From: Dale Branch
Sent: 20/04/2022 3:08:49 PM
To: Council Northernbeaches Mailbox
Cc: Janelle Branch; Steve Branch
Subject: 816 Pittwater Road, Dee Why - Submission on (DA2022/0145)
Attachments: 220420 - Final Submission - 816 Pittwater Rd (Reduced).pdf;

RE: Submission – DA2022/0145 – 4 Delmar Parade and 812 Pittwater Road, Dee Why

This submission has been prepared in relation to DA2022/0145 (the application) at 4 Delmar Parade and 812 Pittwater Road, Dee Why (the site). It has been prepared on behalf of the owners of the adjacent lot to the north and west of the site at 816 Pittwater Road (see **Figure 1**). DA2022/0145 seeks approval for demolition works and the construction of a mixed-use development comprising a five and seven storey residential building above two common basement levels (the Proposal).

Figure 2 North-facing Apartments in Building B

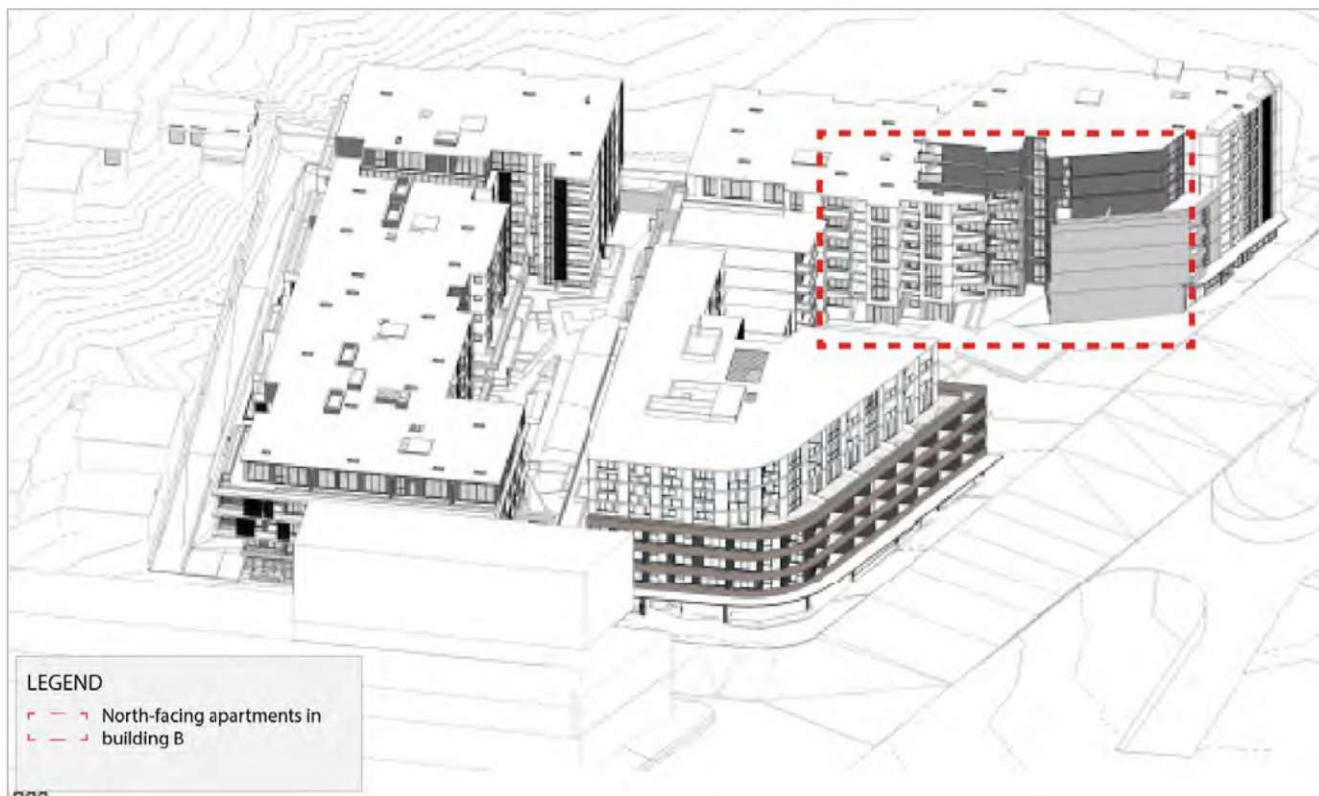
The ADG requires that living rooms and private open spaces of at least 70% of apartments in a building receive a minimum of 2 hours of direct sunlight between 9 am and 3 pm at mid-winter. As commented in the SEPP 65 Statement that accompanies the application, the Proposal suggests that exactly 70% of proposed apartments receive the required two hours of solar access to living room windows and private open space. Of these compliant apartments, it is understood that approximately seven north-facing apartments per level in building B rely on 816 Pittwater Road remaining undeveloped to achieve compliance (see **Figure 2**). No detailed breakdown, or diagrams have been provided with the application to confirm the validity of the suggested compliance.

Contrary to the accepted approach to planning in areas undergoing transition, LEC planning principles and case law; the Proposal gives no regard to the existing or likely future development of 816 Pittwater Road when considering amenity of the proposed development. Council and the Regional Planning Panel cannot knowingly support a DA that relies on the vacancy of an adjoining site, within a key centre of the LGA on a major roadway, to support a case of compliance and good planning outcomes.

Figure 3 Solar Access to Building B with 816 Pittwater Road Developed to its Planning Controls

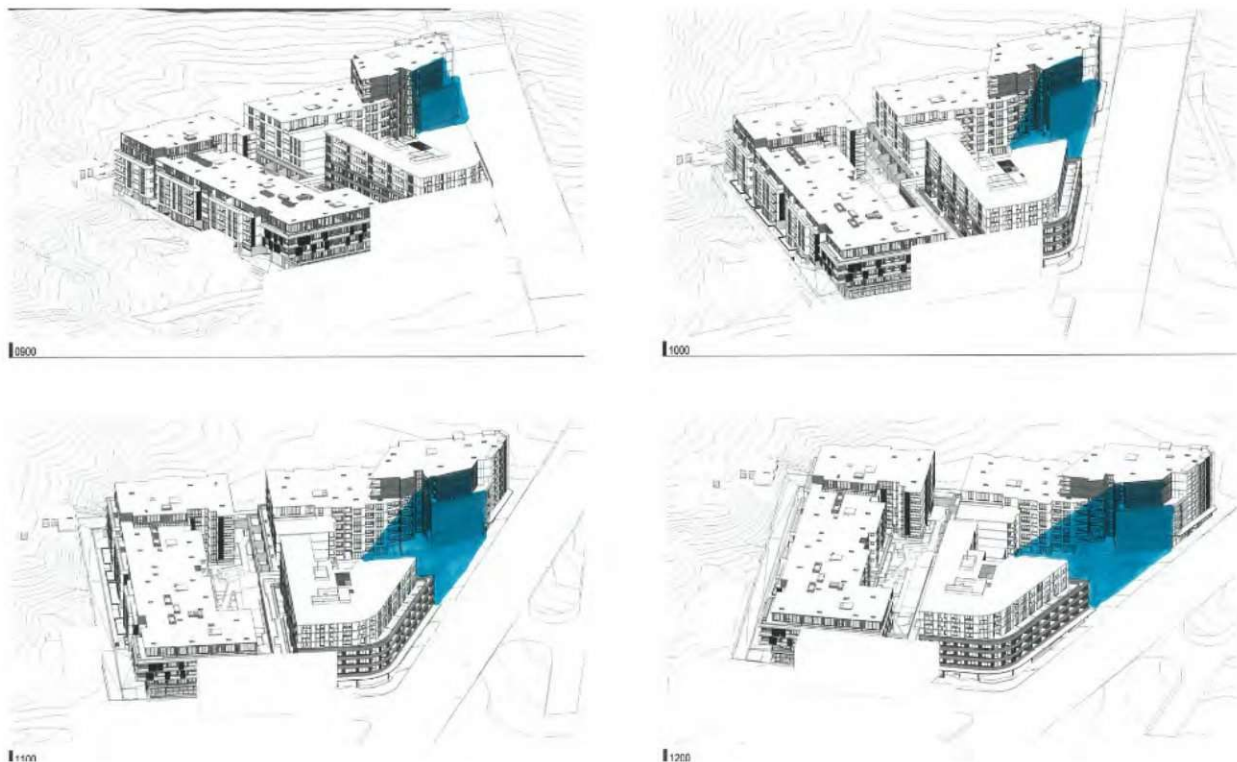
Consequently, any development of 816 Pittwater Road would result in the Proposal no longer achieving compliance with the ADG on the measure of solar access, aside from privacy. This is evident in **Figure 3**, which provides an outline of the allowable built form at 816 Pittwater Road (24m height and 3.2:1 FSR).

As mentioned above, the Proposal's impact on the developability of 816 Pittwater Road is a relevant consideration as well as the impact of a future development on the site. As established in *The Benevolent Society v Waverley Council* [2010] NSWLEC 1082 (previously the *Parsonage v Ku-ring-gai* planning principle), "in areas undergoing change, the impact on what is likely to be built on adjoining sites should be considered when assessing the adequacy of solar access". It is apparent that this has not been given any regard.

As with the proposed building separation and provision of suitable setbacks to enable areas in transition, the impacts of overshadowing to the Proposal have not been appropriately considered and set up a substandard planning outcome for both No 812 and the future development of 816 Pittwater Road.

The solution to the above issues is either the amalgamation of the site and 816 Pittwater Road **or** the Applicant revises their Proposal to provide a 9m building setback to the shared site boundary and account for solar impacts associated with the development of 816 Pittwater to its development potential. This may involve reorientating apartments in Building B.

Figure 4 Proposed Building Separation – Level 5 of Building B

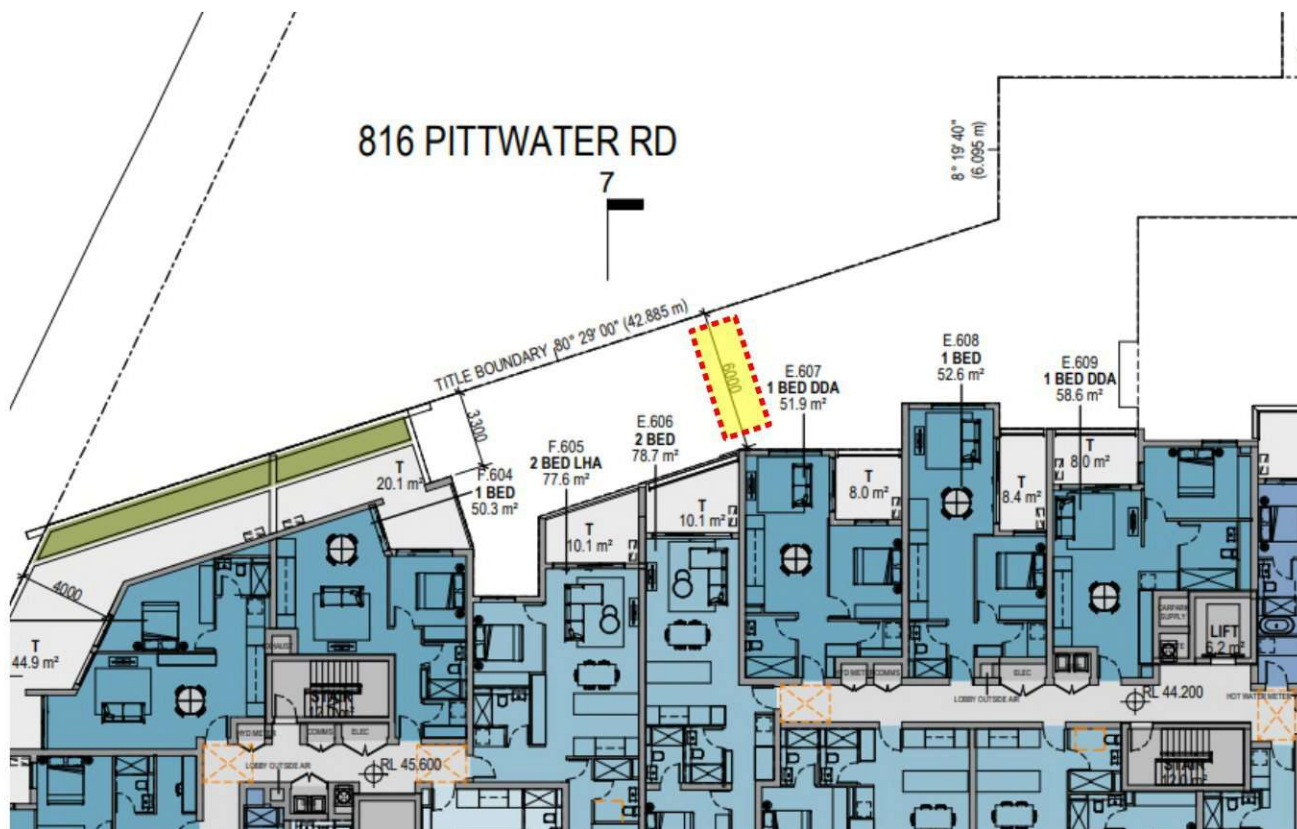
The ADG requires a minimum 6m separation between residential buildings to side boundaries for up to four storeys and 9m for levels 5 to 8 (assuming between non-habitable rooms). Furthermore, the minimum separation between residential buildings is 12m between habitable rooms and balconies for up to four storeys and 18m for levels 5 to 8. As shown in the below extract, the Proposal provides a 3.3m and 6m setback (with windows and balconies) between habitable north-facing balconies of levels 5 to 7 and the shared boundary with 816 Pittwater Road.

In order to comply with the ADG, the north-facing dwellings in Building B would need to be set back by a minimum of 9m or reorientated to face east (parallel with the northern boundary alignment) rather than north to achieve compliance with the ADG and provide for the orderly and economic development of 816 Pittwater Road. Without doing so, a poor planning outcome would be foreshadowed, placing an unreasonable burden on any future redevelopment of 816 Pittwater Road to provide excessive and onerous building setbacks to achieve required building separation distances. As shown in **Figure 5** below, approximately three apartment units would be lost on each level for a residential flat building developed at 816 Pittwater Road due to these onerous building setbacks.

Whilst an argument could be made that future development would not necessarily require full adherence to separation requirements being offset or perpendicular to one and other, perpetuating a scenario that requires this issue and others (privacy, acoustics, overshadowing) to be dealt with offsite at no 816 Pittwater Road is a substandard and poor planning outcome. This is further exacerbated by the Proposal seeking to vary development standards, including a 29% exceedance on 812 Pittwater Road – an indicator of overdevelopment and lack of response to site constraints (including required setbacks).

In order to resolve the above issues, the application must be revised to provide adequate separation (9m setbacks) on the site to comply with the ADG. The setbacks of Building B must also be revised to account for the solar impacts associated with the development of 816 Pittwater to its development potential as anticipated by the combined development controls. This may involve reorientating apartments in Building B.
